A G E N D A
FARRAGUT MUNICIPAL PLANNING COMMISSION

January 21, 2016
7:00 p.m. Farragut Town Hall

SUBJECT: STAFF COMMENTS ON THE NEW SITE PLAN FOR THE OVERLOOK AT CAMPBELL STATION APARTMENTS, PARCELS 108 AND 109, TAX MAP 130

160' EHRESMANN MONOPINE

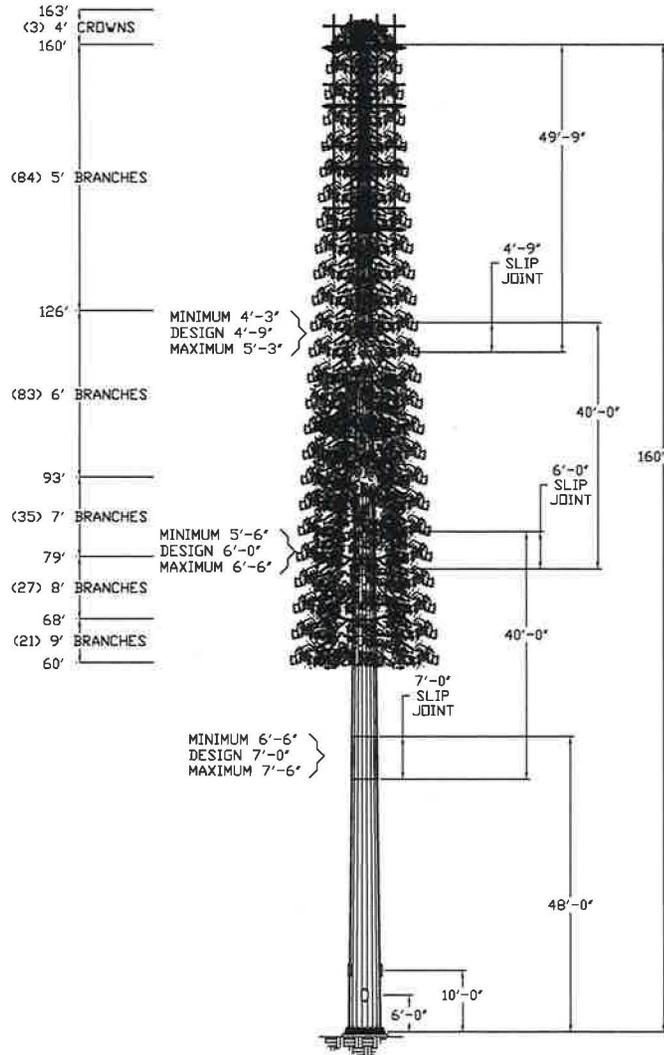
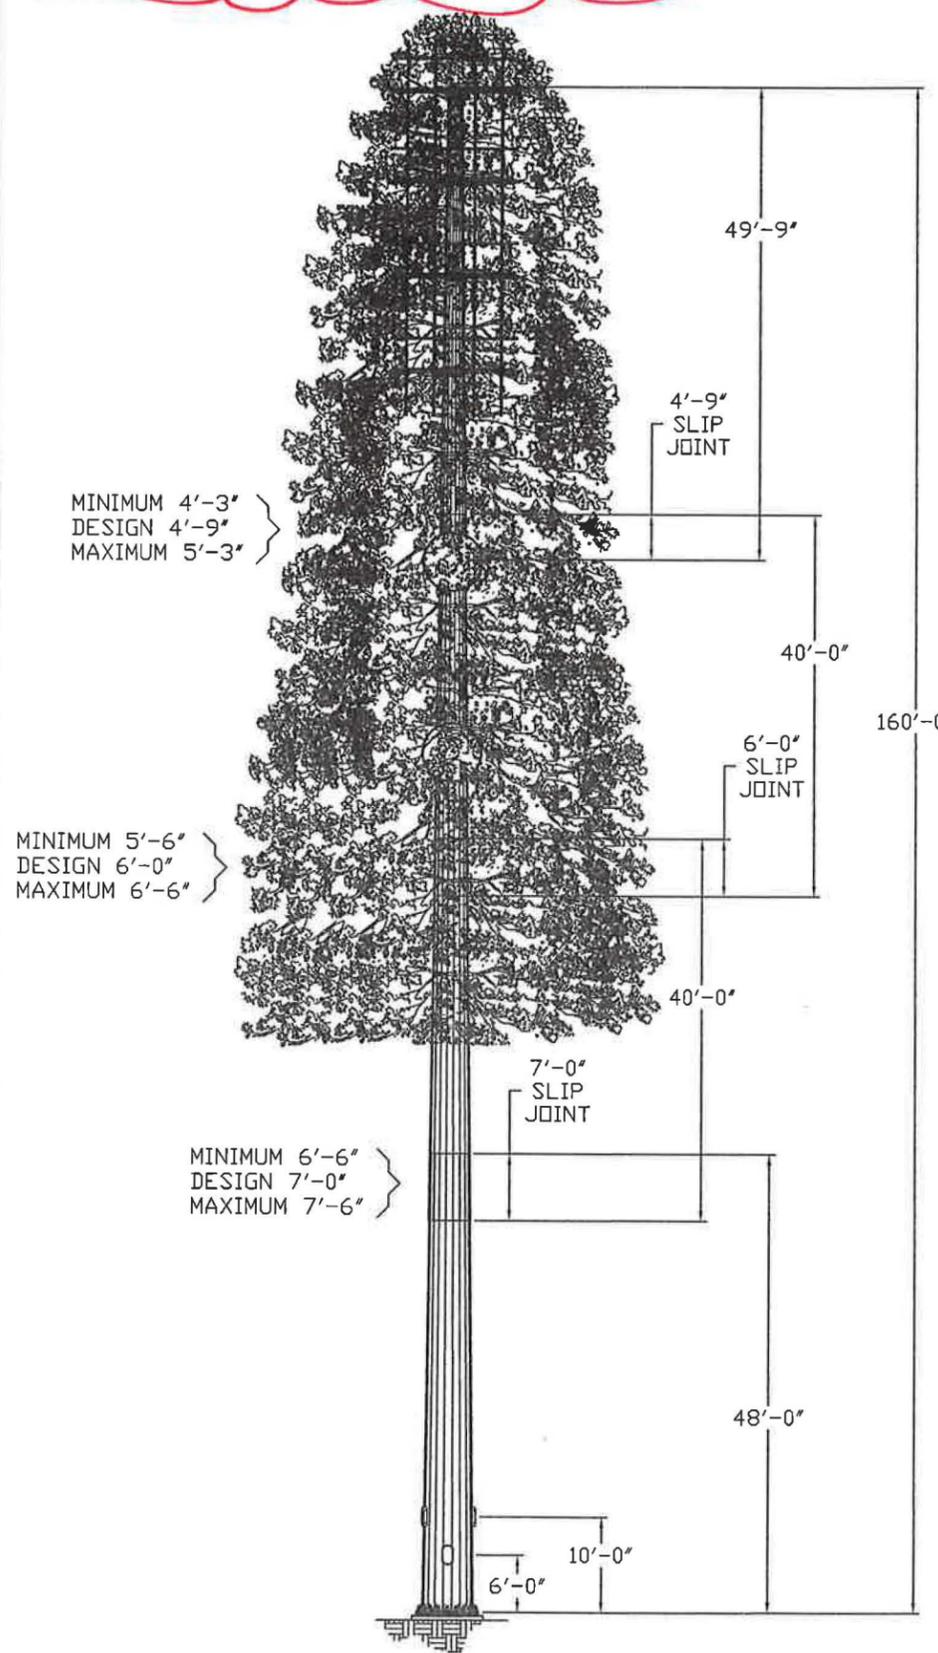
At the meeting, the applicant handed out a revised drawing of a mono-pine application which included general dimensions. Though the applicant made some verbal reference to the anticipated width of the mono-pine to be used, the drawing that was submitted at the meeting, based on dimensions provided on the drawing, did not correspond with what the applicant is actually proposing.

The drawing that was submitted shows a mono-pine application that is over 40 feet in width at its base and that has a general tree-like appearance. When this was noted to the applicant in response to addressing item "e" in the minutes, the applicant acknowledged that an error had been made and the drawing that was submitted does not reflect what the applicant is proposing. The proposed mono-pine application would actually be 18-20 feet in width at its widest dimension.

Since the mono-pine application was a condition of the rezoning and a very important aspect of the site plan the staff did not feel comfortable approving a modification that would be substantially different from what was shown at the meeting.

Consequently, this item is back for your consideration. Included in the packet is a copy of the drawing that was provided at the November meeting and a drawing and photographs of what the applicant is proposing with dimensions noted. Compared to the rendering that was presented at the meeting, the revised rendering which the applicant is proposing is not as tree-like in appearance. The staff would recommend something more consistent with the rendering that was provided at the November meeting.

TITLE: OVERALL SITE PLAN LOCATION: 820 N CAMPBELL STATION ROAD FARRAGUT, TENNESSEE 37932 CLT Map 130, Parcel Nos. 108 & 109	DRAWN BY: - CHECKED BY: - FILE NAME: 2086 - C1.0 JOB NUMBER: 2086	SHEET NO: C1.0
Owner: PEF FARRAGUT, LLC	ISSUE DATE: 12/18/2015

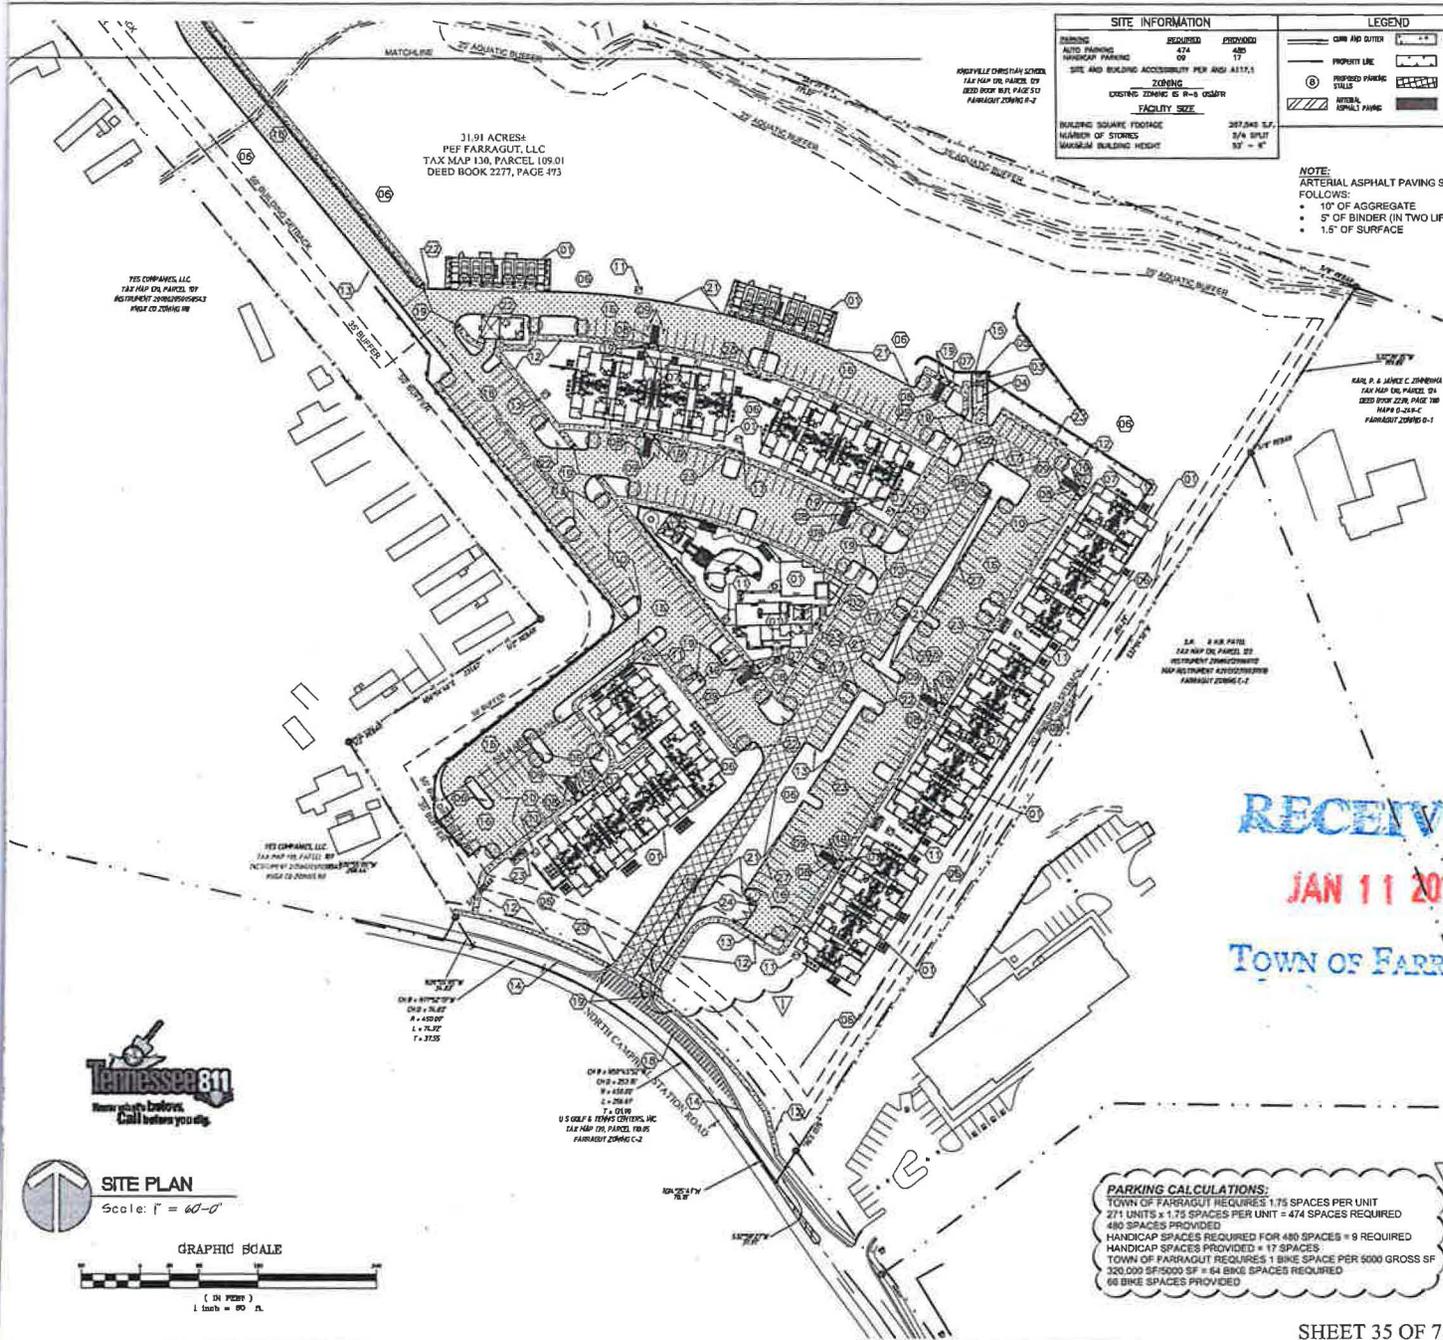
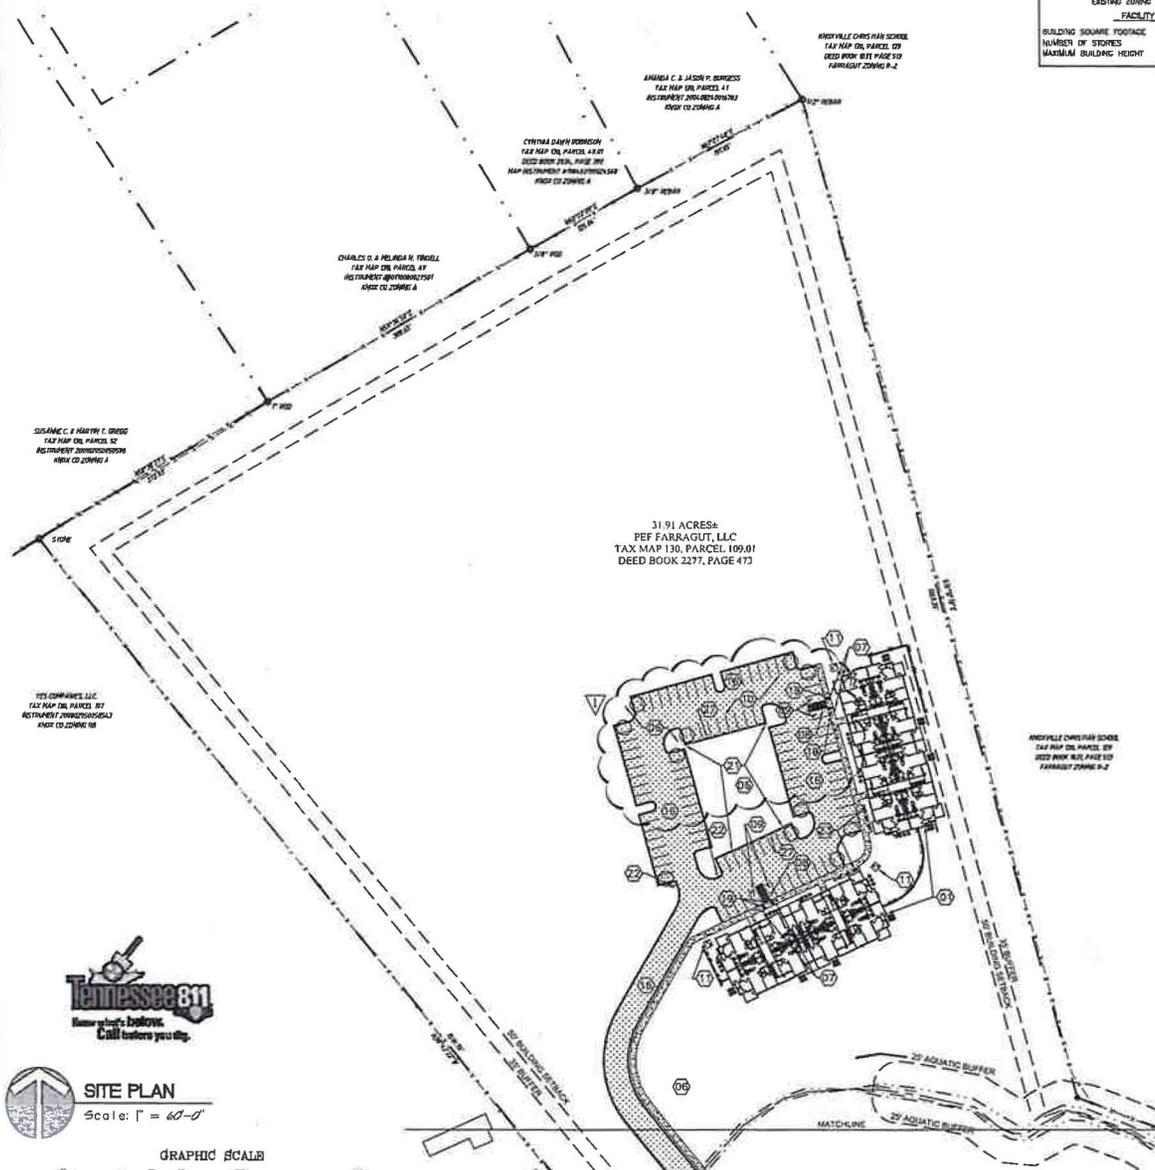
- 1) Please provide adequate turning radius for a 53 foot long single axle aerial fire apparatus at point prior to bridge, where two aisle ways intersect at an angle. (by bldg. 9);
- 2) Please provide a remote emergency access road, in accordance with IFC D106, to provide a secondary access for emergency purposes;
- 3) Please provide the current fire hydrant flow data for the closest fire hydrants used to satisfy Appendix B and C. Data shall be less than 1 year old and include name of agency performing test, static pressure, residual pressure and flow in GPM.(data is from 2013);
- 4) Please provide written approval from First Utility District of Knox County. The data provided is from 2013;

- 10) Related to the previous comment, the additional disturbance along the drainageway is inconsistent with the intent of the OSMFR Zoning District Overlay. This additional disturbance will cause the removal of specimen trees that could otherwise be saved with the prior submittal that was discussed with the planning commission where the bridge would completely span the drainageway. The staff does not support this increased disturbance since alternate measures are available and have already been proposed by the applicant;

- 11) As was noted when this last came before the planning commission, this new site plan must adhere to all aspects of the adopted Architectural Design Standards (ADS). The plans that have been submitted are in conflict with the following standards:

- 21) Vinyl siding for the dumpster enclosure and compactor does not comply with the ADS as this is well beyond an accent treatment;
- 22) To provide for a looping option the staff would recommend a pedestrian connection from the southwest parking lot sidewalk to the pedestrian facility along N. Campbell Station Road;

- 29) Please show the proposed height for the parking lot pole lights;
- 30) Are there any other exterior lights proposed? If so, please include details on the plans;

- 31) All HVAC units must be screened by the building they are serving. The civil sheets need to show a detail of how this is being addressed;
- 32) Please remove reference to "Not for Construction"

- 33) Please add the aquatic buffer note and please adjust the spelling of this term on the plans;
- 34) Please verify that the sidewalks abutting parking spaces are 6 feet wide to adjust for car overhang so that at least 5 feet of clear sidewalk area is provided;
